PLANNING DIRECTOR'S MODIFICATION
(P90-169)

APPLICATION: Planning Director's Modification of a Plan Review for a 14 unit single family subdivision.

LOCATION: East side of Lacam Circle adjacent to Southern Pacific Railroad tracks

APPLICATION: A. Negative Declaration
B. Plan Review for fourteen single family residences on 2.73± vacant acres in the Standard Single Family Review (R-1R) zone.

EXHIBIT B
FLOOR PLAN / ELEVATIONS

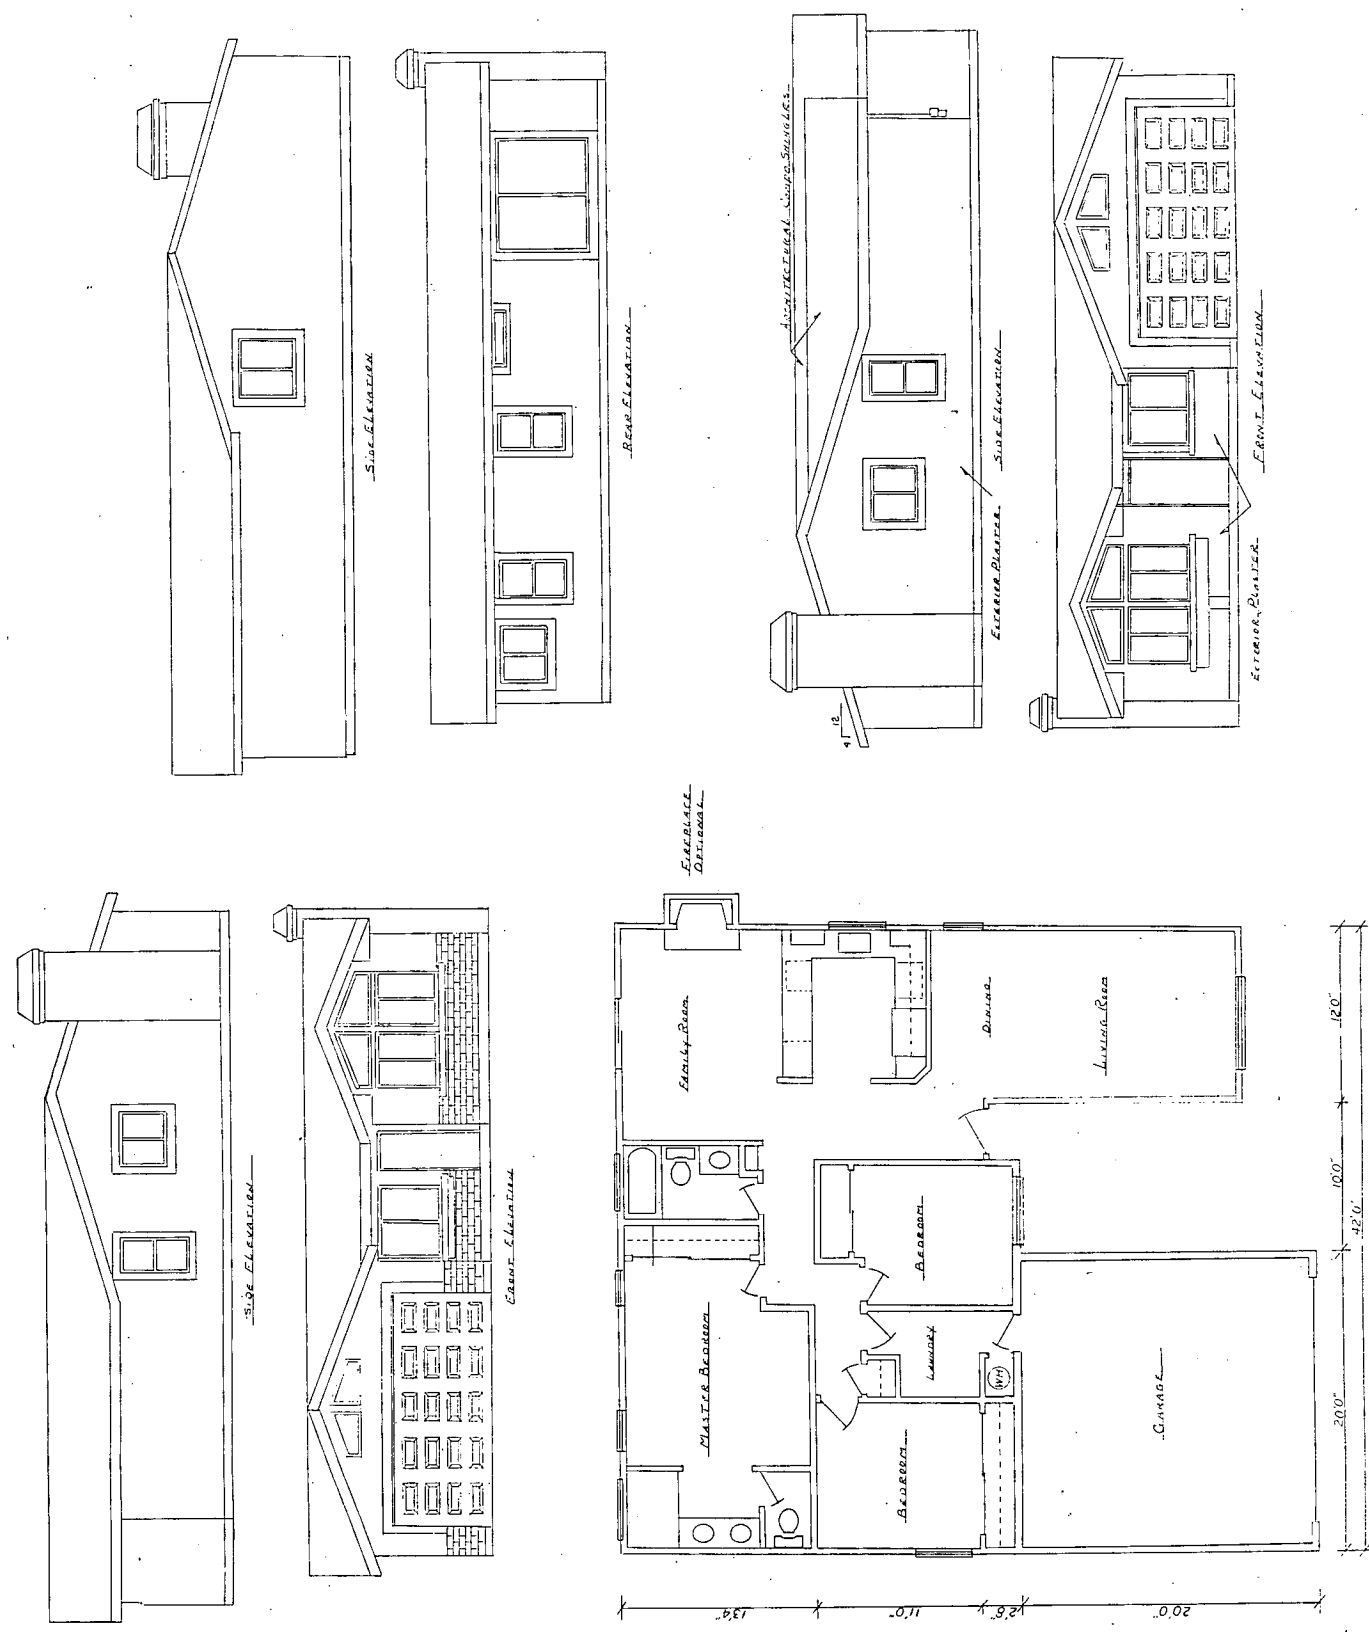
- 1) The applicant is requesting to use a variation of 4", 6" and 8" horizontal wood siding on the front, rear and side elevations of twelve of the units instead of stucco.
- 2) On units 2 and 3 the applicant has requested that horizontal wood siding be used on the front elevations but T1-11 be allowed on the rear and sides of these two units only instead of stucco.

- 3) The plans which were submitted and approved indicated that the same roof line would be used on all fourteen units. The applicant has requested that we allow a variation of Hip, Gable, Clipped Gable and Dutch roof styles within the subdivision.

The applicant is requesting a plan review in order to construct fourteen 1,380 square foot single story residential units. The same basic floor plan of three bedrooms, two bathrooms and a two car garage is being proposed on all fourteen units. Two different elevations are being proposed with five different exterior and trim colors consisting of earthtones (ivory, tans and grays). The applicant is proposing a brick wainscoting to the bottom of the windows on some of the units (see Exhibit B, Elevation A).

1. The applicant should revise the floor plans in order to allow full view of the front door;
2. The front doors on the units should be panelled metal with a minimum of six panels;
3. The garage doors should be metal sectional roll up doors;
4. The residences should be staggered a minimum of five feet from each other along the street and the proposed elevations should also be alternated;
5. Front lawns should be fully landscaped with at least one five gallon tree to be planted on each lot;
6. No mechanical equipment, such as air conditioning units, should be visible from the street; and
7. The applicant should utilize the five following color schemes:
 - a) Cloud Gray with True Gray Trim
 - b) Ivory with Camel Gold Trim

1. On Lots 2 and 3 the applicant will use a 4", 6" or 8" horizontal wood siding on the front elevation and T1-11 on the sides and rear;
2. On Lots 1 and 4-14 the applicant will use a mix of 4", 6" and 8" horizontal wood siding on the front, rear and side elevations;
3. Brick wainscoting shall be used on all of the odd numbered lots starting at Lot 1 ending at Lot 11 and also on Lot 14.
4. A 25 year laminated dimensional composition shingle roof shall be used on all fourteen lots within the subdivision.
5. The applicant shall submit a revised masterplan indicating the following prior to obtaining a final inspection on any of the fourteen units:
 - a) The actual front, rear and side setbacks for all fourteen units indicating what has actually been constructed;

1. The design of the units shall include the following:
 - a) The front doors shall be panelled metal with a minimum of six panels;
 - b) The garage doors shall be metal sectional roll up doors;
 - c) The applicant shall utilize the five following color schemes or submit to planning staff a revised set of colors for review and approval by staff:
 - (1) Cloud Gray with True Gray Trim
 - (2) Ivory with Camel Gold Trim
 - (3) Aspin with Aztec Gold Trim
